Historic Preservation Board

- i. Preliminary Review of Proposed New Construction; 58 FORE STREET (BLOCK 4) Portland Foreside Development Company, Applicants. A project and plan summary are available for viewing on the city's CSS Portal (<https://css.portlandmaine.gov/>) by referencing Plan Number HPBR-002380-2023.
- ii. Preliminary Review of Proposed New Construction; 58 FORE STREET (BLOCK 6) Portland Foreside Development Company, Applicants. A project and plan summary are available for viewing on the city's CSS Portal (<https://css.portlandmaine.gov/>) by referencing Plan Number HPBR-002391-2023.

STAFF MEMORANDUM HISTORIC PRESERVATION PROGRAM PLANNING AND URBAN DEVELOPMENT

Re: Portland Foreside Development Company
58 Fore Street/Mixed Use of Blocks 4 and 6
Major Site Plan Review Application

Figure 1: Map of 58 Fore Street site provided by applicant showing the Portland Company Historic District boundary (solid red line), and the area of the proposed Block 4 Development (purple shaded area labeled “Harbor Hill”). Block 1 (green shaded area) was previously approved and is nearing

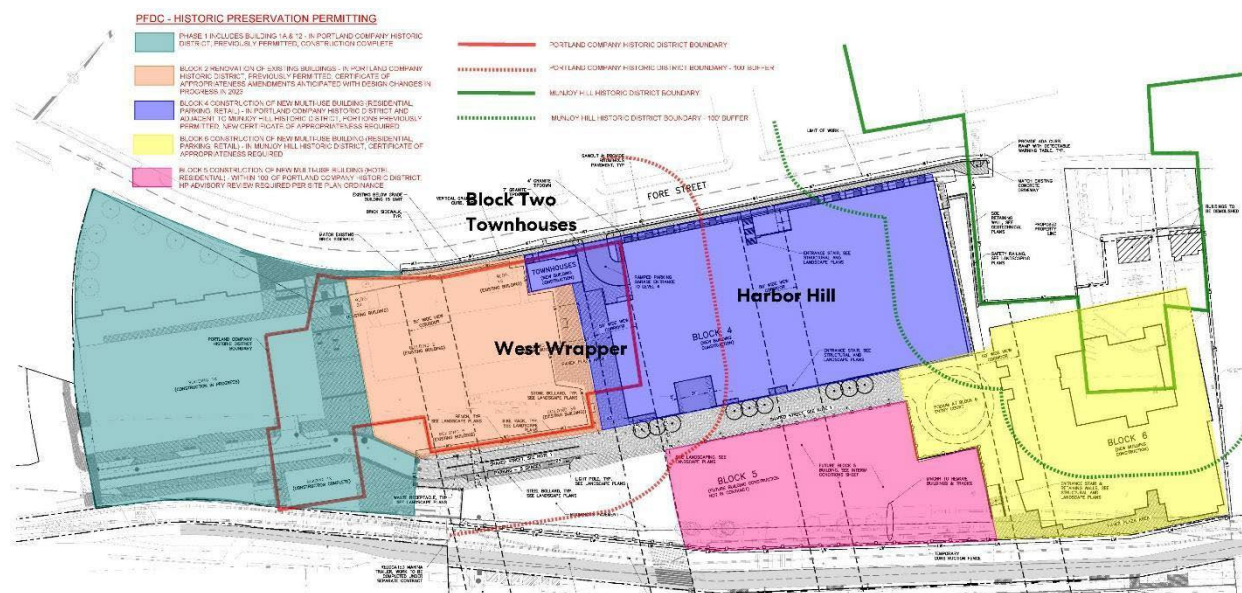
Those portions of the structure that are within the boundaries of the Portland Company Historic District require a Certificate of Appropriateness (COA). These elements include the two westernmost townhouses, the west wrapper, and the driveway podium structure (see figures 1 & 2). The remainder of the structure will be subject to an advisory design review by Historic Preservation Staff in conjunction with Portland’s Urban Designer as a part of the Site Plan Review for Block 4. This review is ongoing and has had one workshop with the Planning Board.

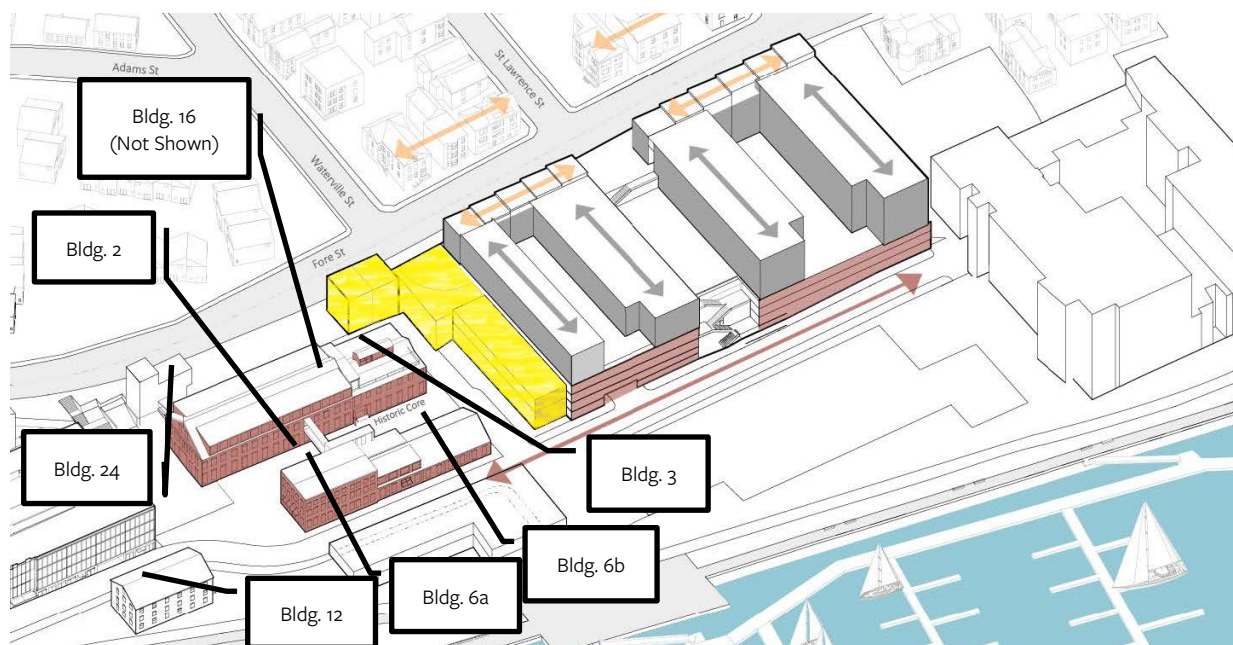
The applicant has provided a revised set of drawings and renderings for a second workshop. The revised application package includes a number of additional views of the proposed development as requested in the first workshop, as well as several design changes that address Board comments from the first workshop. The additional views include, a view from within the Historic District looking towards the proposed Block 4; close-up views of the base of the Block 2 townhouses including from the alley between building 3 and Fore Street; a colorized section through the alley; a view of the townhouses from Waterville Street; and a view from the top of the driveway podium. The revised submission is also focusing on the portions of Block 4 that are subject to Historic Preservation Board approval for the purposes of this workshop. The most significant design changes since the prior workshop are found at the driveway podium and the base of the Block 2 townhouses.

The driveway podium has been heavily revised to be clad in an articulated walls system similar to the propose cladding of the west wrapper and that has a visual relationship with open metal frame of the Building 4 remnants at the east end of Building 3. The cladding breaks the mass into three horizontal bands, which are further broken down with recessed and vertically oriented filler panels. The exact materials are not clearly indicated; however, the renderings suggest a metal cladding

At the Block 2 Townhouses, the applicant has significantly redesigned the treatment at the level of the Historic District. In the original application, the base was recessed, and the upper four floors slightly overhung the first floor. In the revised proposal, the townhouses have a much stronger base, utilizing a framework and divided light pattern similar to what is proposed for the west wrapper. This creates a visual unity for the retail spaces around the plaza. The use of an over height first floor, also similar to the west wrapper, helps to reduce the perceived height of the townhouses to five stories from within the Historic District.

Height Overlay Section MAX 45'

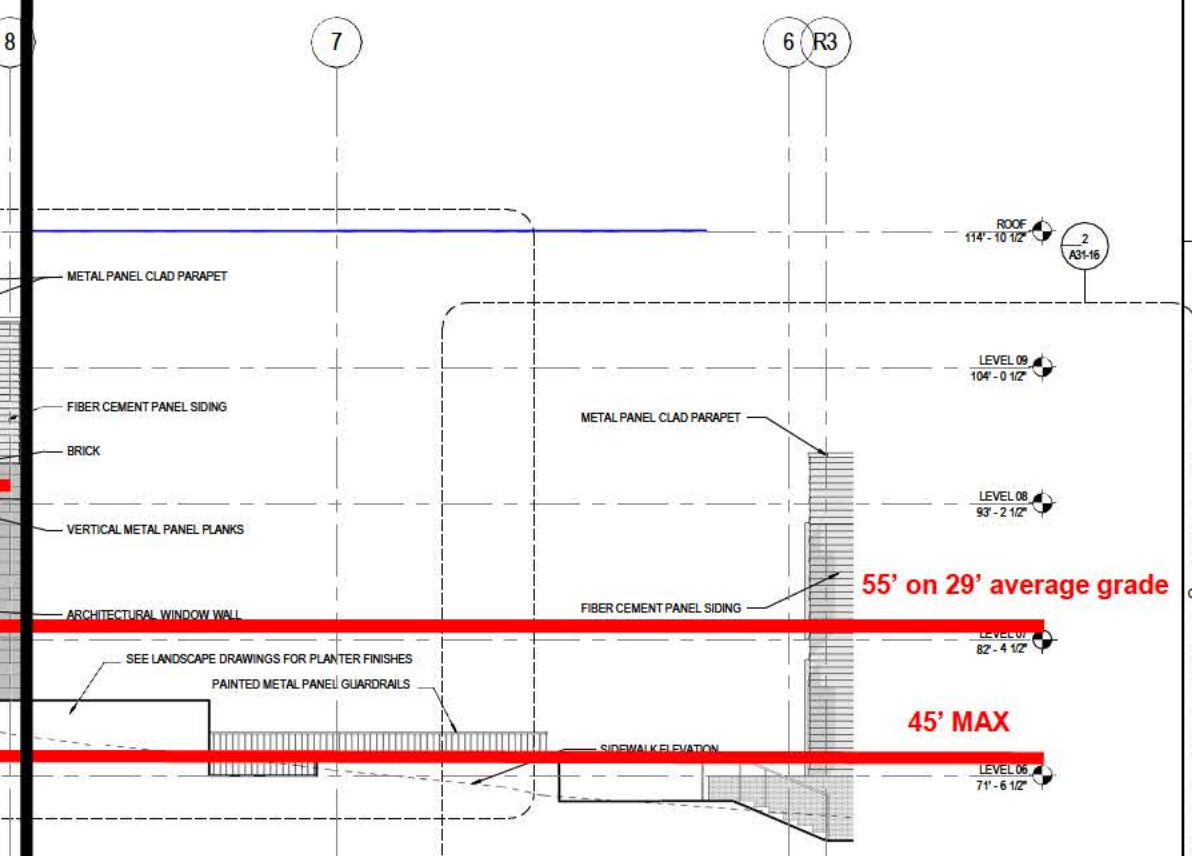
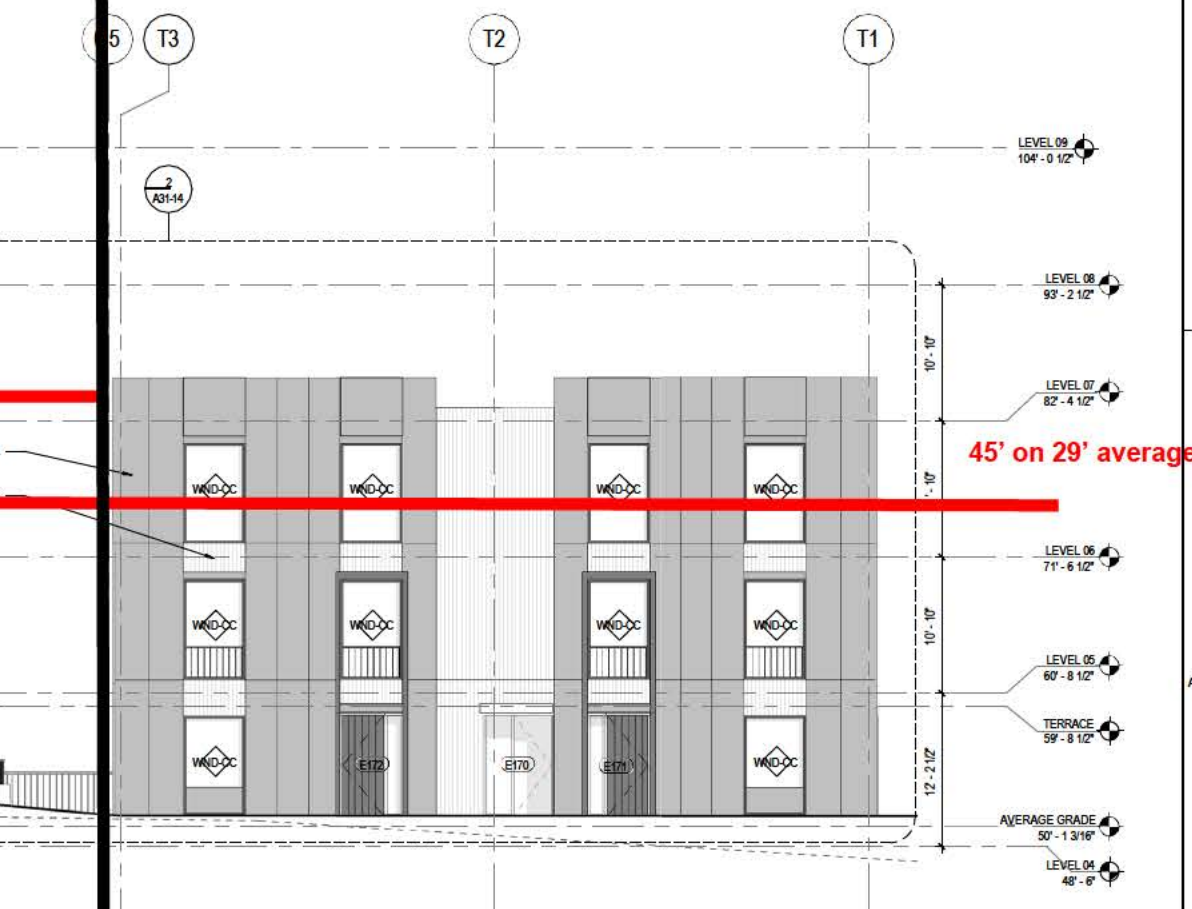
The City’s 2015 and 2022 code utilizes a simplistic methodology for determining the average grade of a site that is easily manipulated and can generate dramatically inconsistent results. The methodology involves calculating a simple average of the grade elevation at the primary corners of the building foundation. This methodology is most applicable if the site is small and generally uniform; it is not appropriate for a large, irregularly shaped and undulating site as that proposed for the 58 Fore St. project. This methodology was utilized during the original Master Development Plan review phase when it was applied to a large parking podium that would be constructed across Blocks 4, 5, and 6. By heavily weighing the high sides of the site, the Applicant (and apparently the City) erroneously determined that the average grade of the site was 50.1 feet.

Engineering consultant, Tetra Tech, performed a more accurate assessment of the site utilizing more applicable industry standard methods (see Attachment A). This easily reproduceable analysis determines that the average grade of the Block 4, 5, and 6 area is in reality approximately 29 feet—a *difference of over 20 feet*. Given the importance of the site in terms of its impact on the overall character of Portland and surrounding Munjoy Hill historic community, it is extremely important for the City to get the issue of grade and subsequent building height correct. It is not acceptable to use and manipulate a simplistic and flawed methodology to establish an incorrect starting grade that enables buildings that far exceed the maximum heights (45 to 65 feet) and number of floors (max 4-6) envisioned in the adopted height study plans⁴ and in the Code.
